Warwick District Green Party initial response to Newbold Comyn masterplan

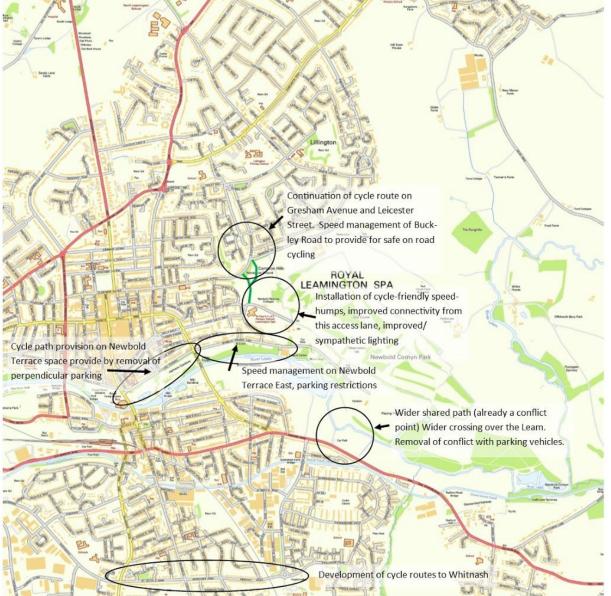
As it stands the Masterplan includes no details of off-site improvements to provide for sustainable transport modes. Yet improvements to the cycle route network from the surrounding urban areas are necessary and could be readily achieved. For example, some key

locations for improvement are suggested on the attached map.

Here are four suggested improvements to walking and cycling routes to improve access into Newbold Comyn:

i) Create a walking and cycling route out of the Comyn directly onto the canal towpath at the south east end. This would mean that the Sustrans route 41 (Lias Line) would travel the length of Newbold Comyn before heading to Radford Semele, Offchurch and on to Rugby.

ii) Improve the route into the centre of Learnington. Note that this route is also on the Lias Line, which continues onto Learnington and Warwick train stations. It should also be noted that any increase in vehicles accessing Newbold Comyn will reduce the safety and amenity of this access road which forms part of the existing SUSTRANS route. This is already being discussed within the Climate Emergency working party and so co-ordination between this project and the Climate Emergency plan is essential.

iii) Minor improvements from Lillington.

iv) Minor improvements from South Learnington (sort Radford Rd entrance and link to canal and Sydenham Drive).
